CITY OF DURHAM + DURHAM OUTDOOR AQUATICS STUDY

WHEELS FUN PARK RINK - CODE ANALYSIS

AUGUST 19, 2022

Wheels Recreation Center

RINK

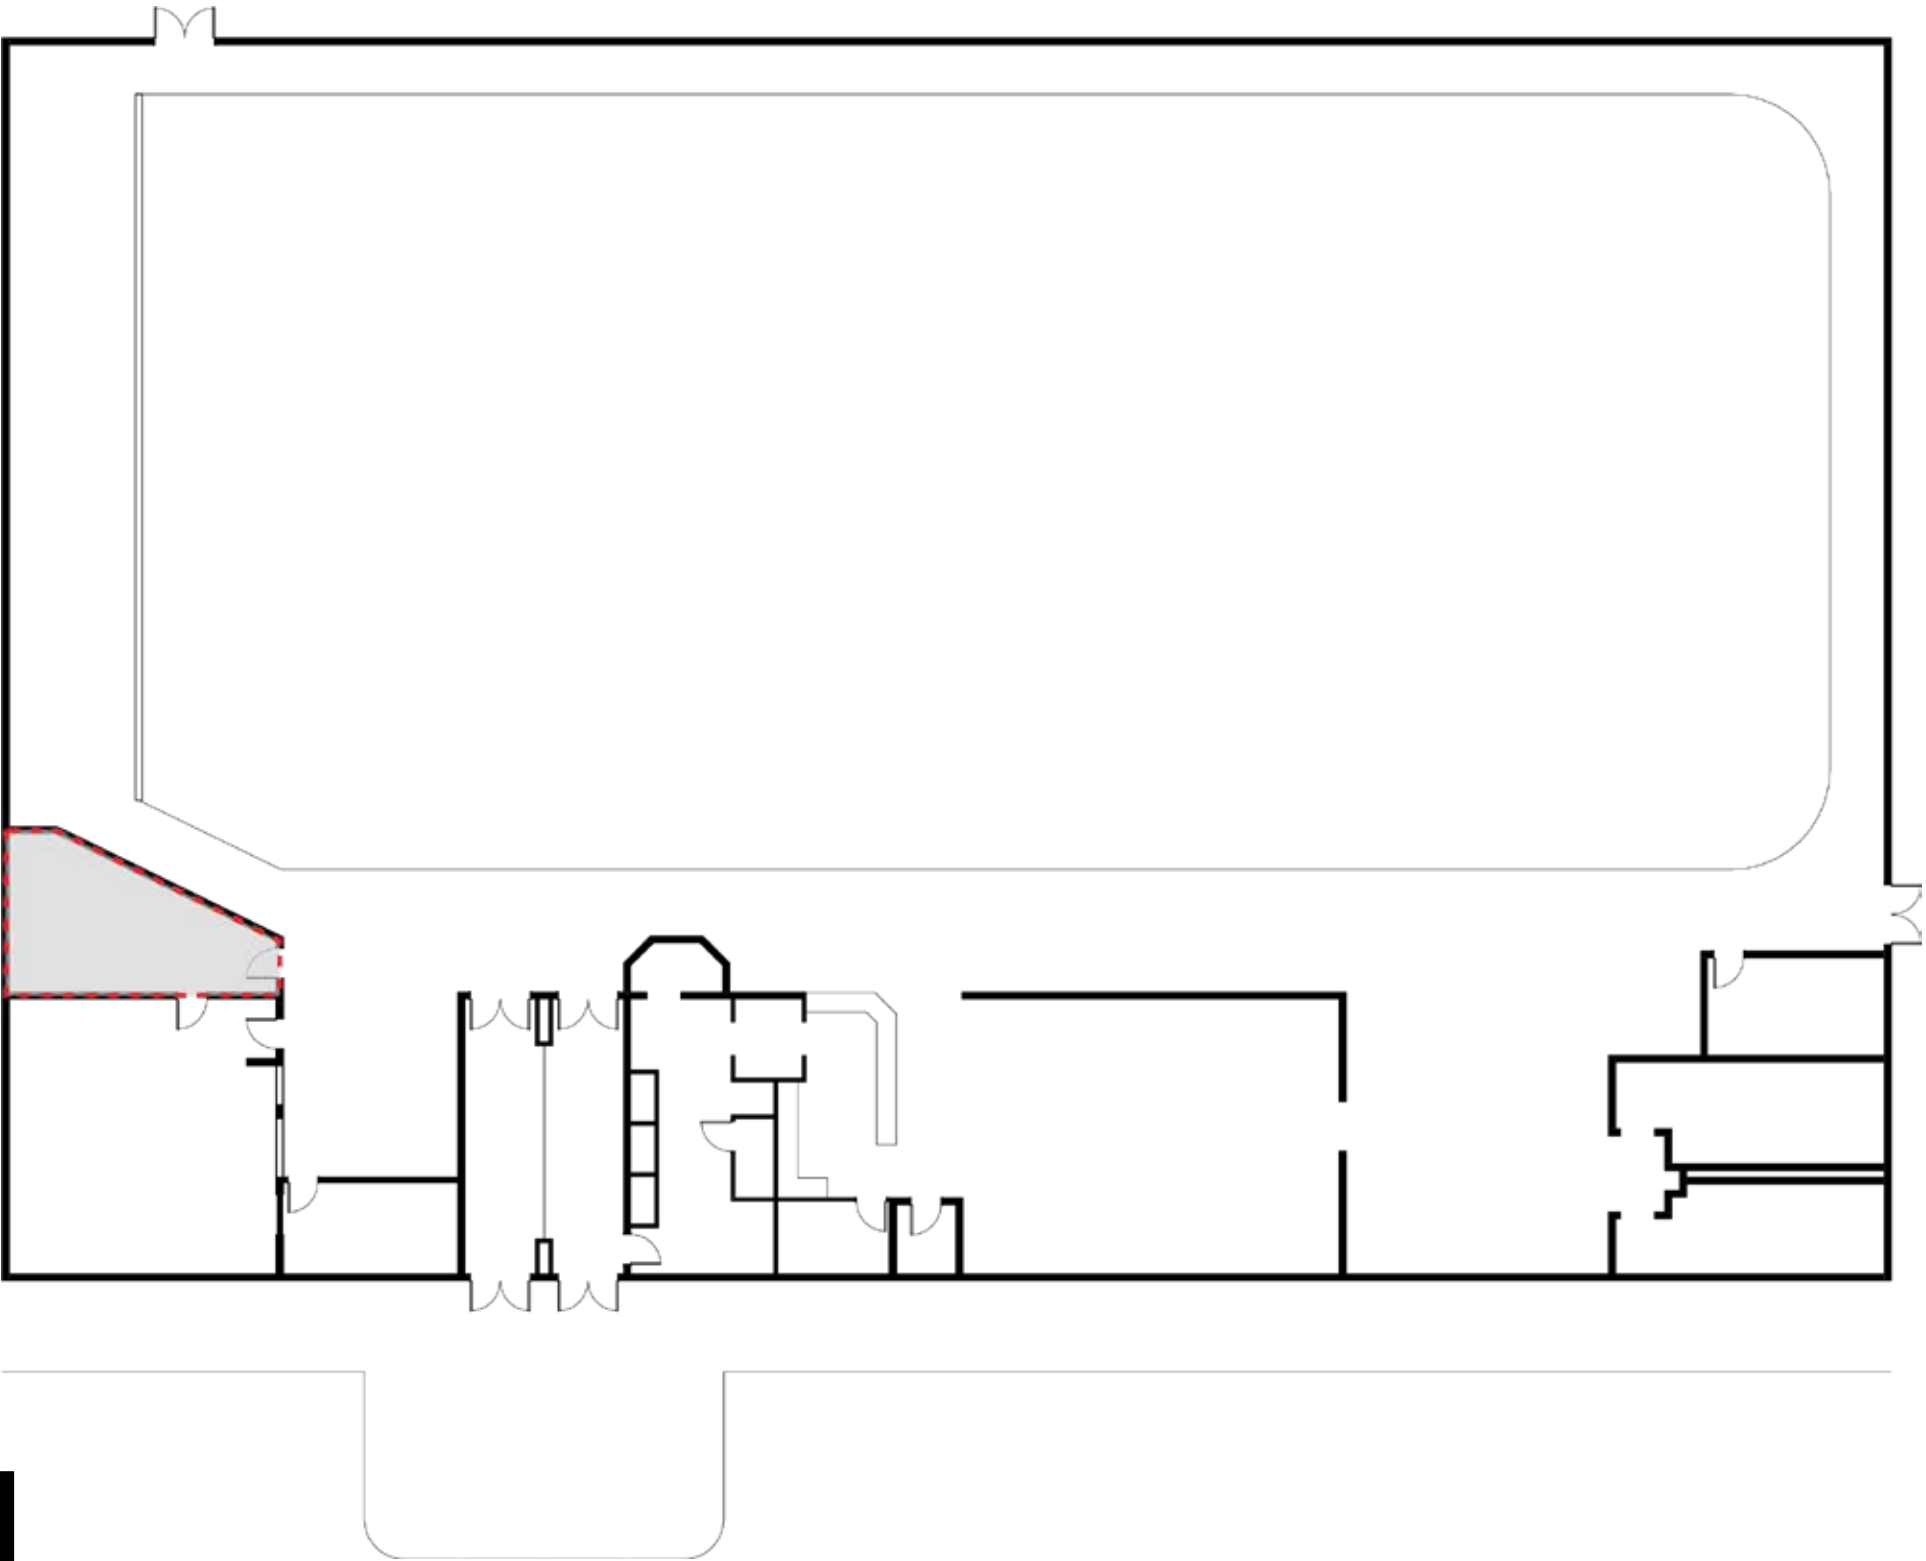
- Stage obstructs accessible route of egress to the north door.
[2017 ICC A117.1 - Section 402]
- There is no accessible route from the walkway to the rink floor. Solution to add proper accessibility could be to add a ramp or remove a portion of the raised floor. [2017 ICC A117.1 - Section 402]
- While not an accessibility issue, there is a 1"-2" gap between the rink floor and the edge of the walkway. This could potentially become a hazard. Add trim to prevent this issue.

- The security bar used to keep the egress doors shut will need to be removed prior to opening.

PARTY ROOM

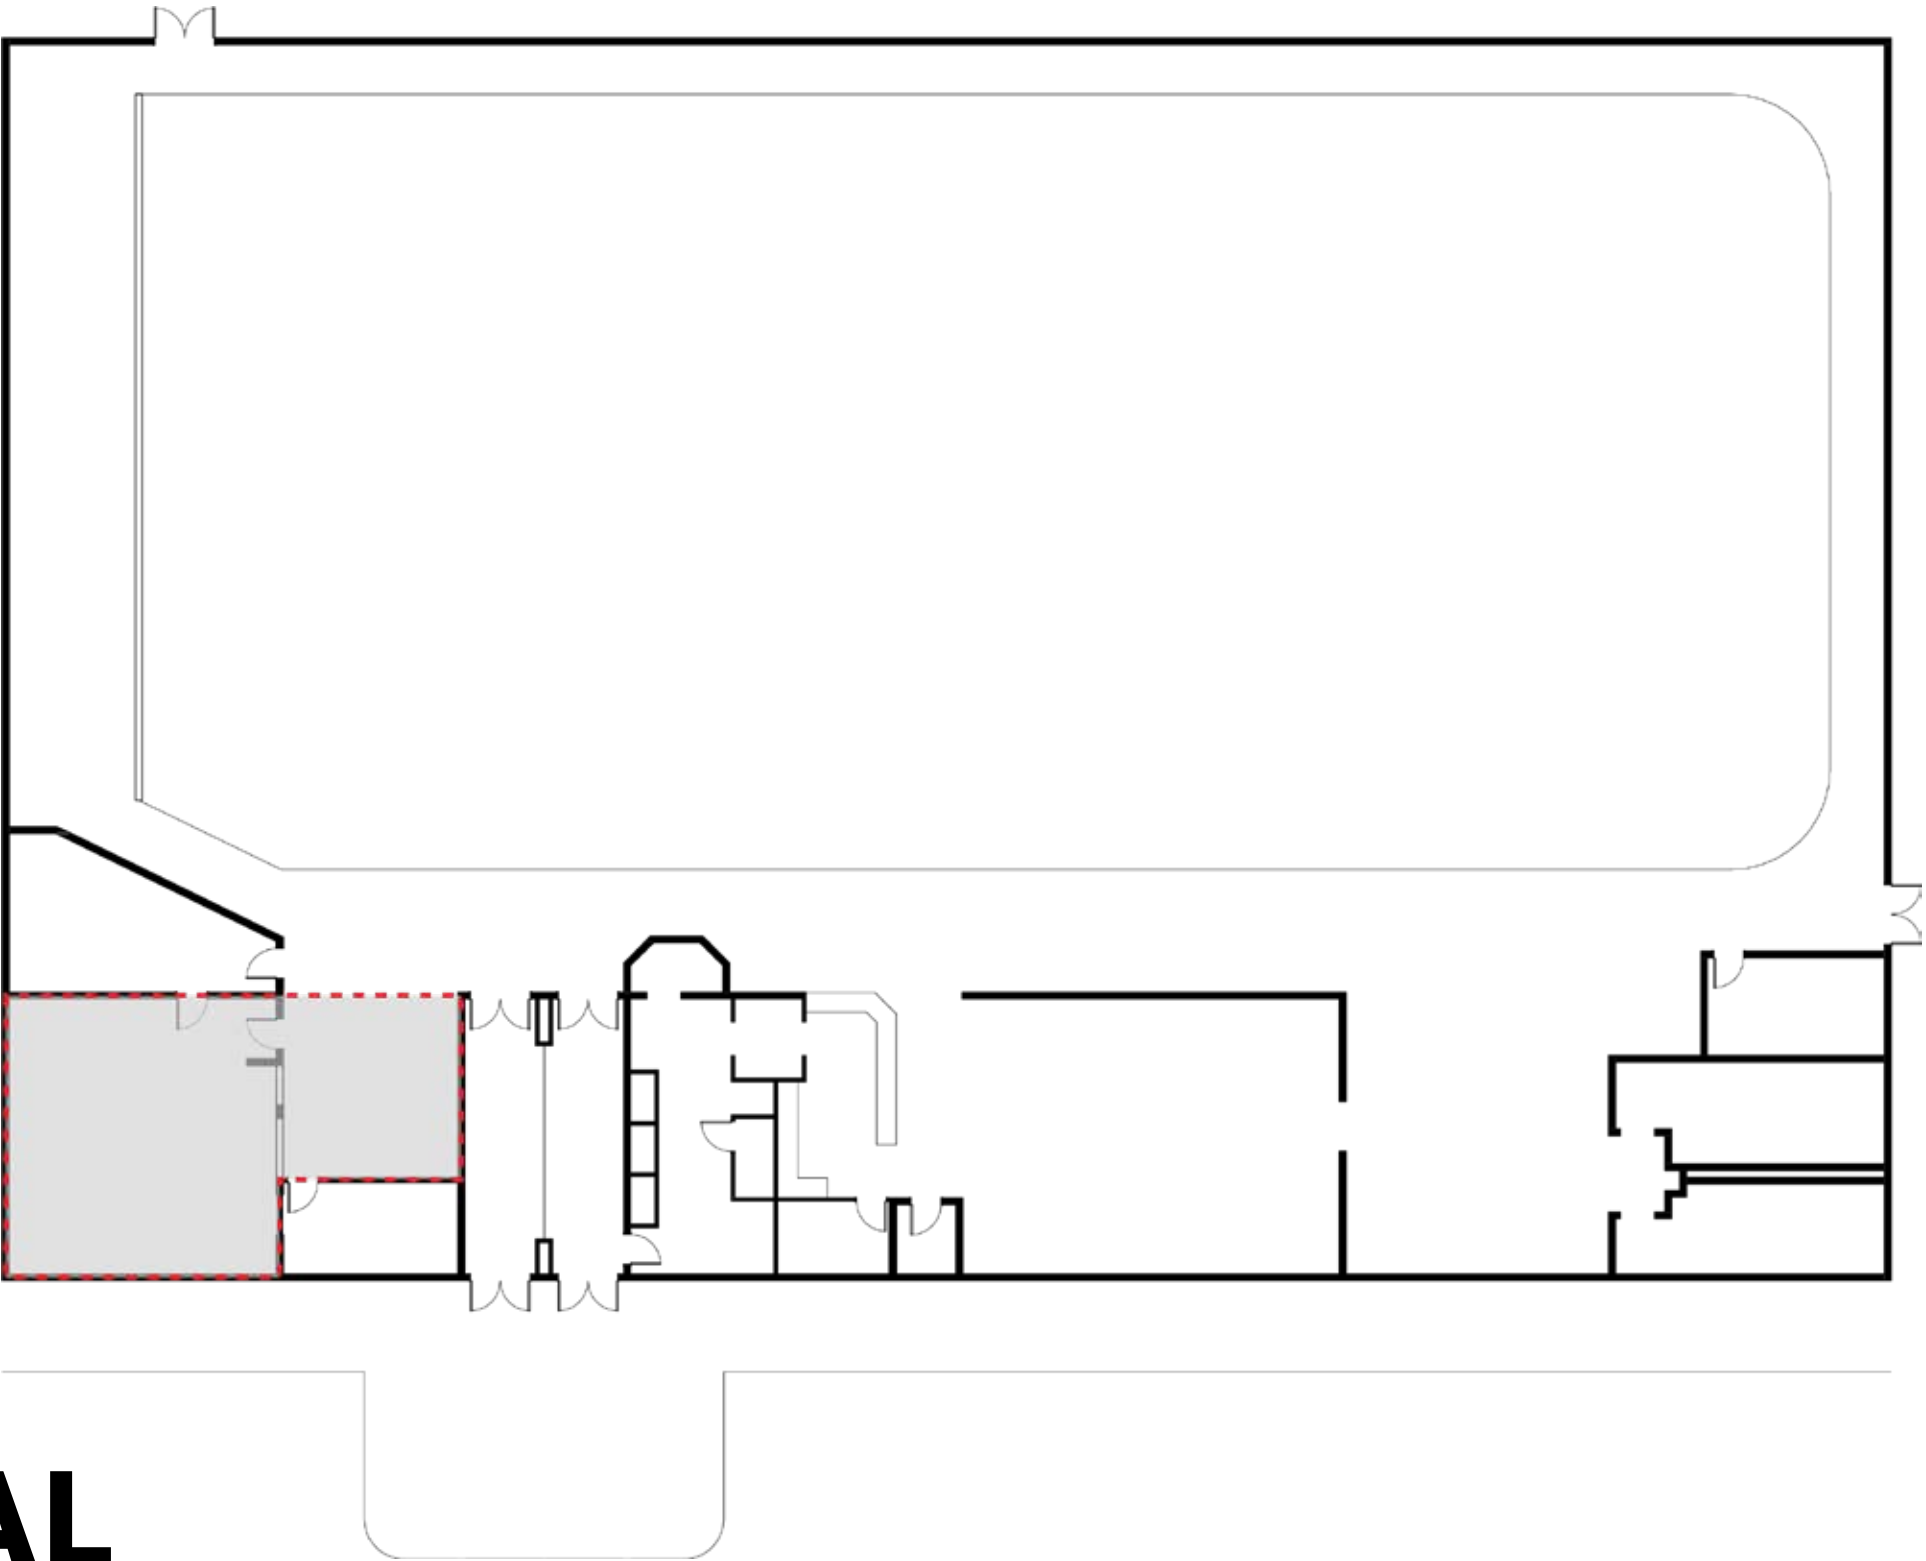
- Accessible pull clearance on the entry door to the party room does not have the proper clearance. [2017 ICC A117.1 - Section 404]
- While not an accessibility issue, loose wire on the wall could be a problem.
- Door hardware on each of the two doors in the party room area will need to be replaced from knobs to levers. [2017 ICC A117.1 - Section 309]

SKATE RENTAL

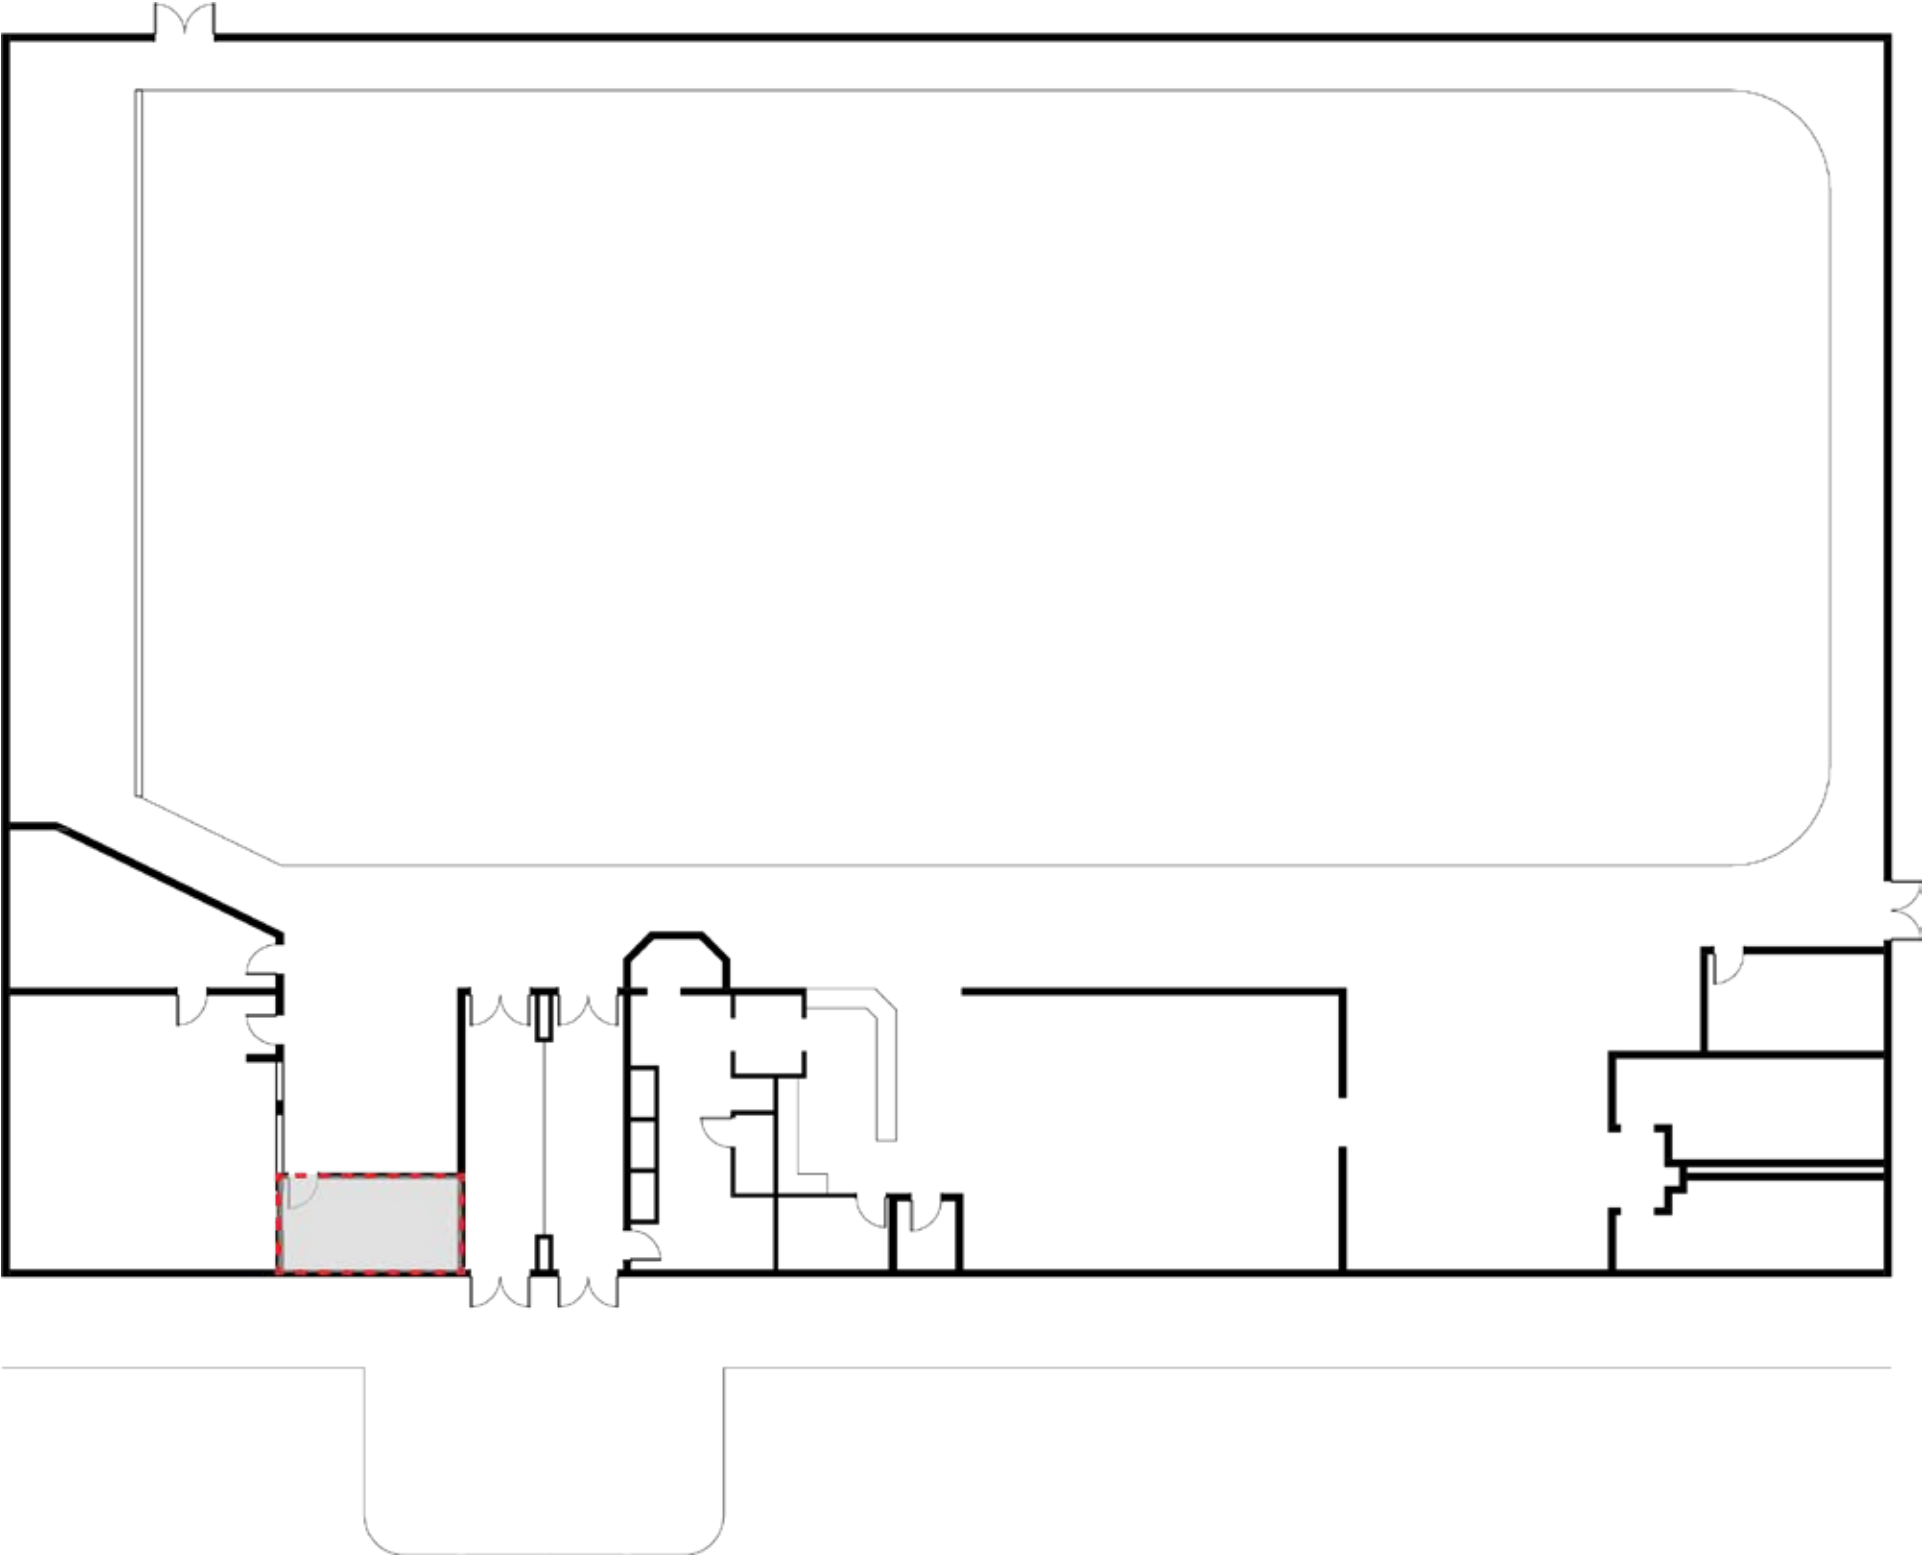
- The pull clearance inside the skate rental door does not meet accessibility standards. Wall will need to be shifted by at least 4". [2017 ICC A117.1 - Section 404]
- Door hardware on the door in the skate rental area will need to be replaced from knobs to levers. [2017 ICC A117.1 - Section 309]
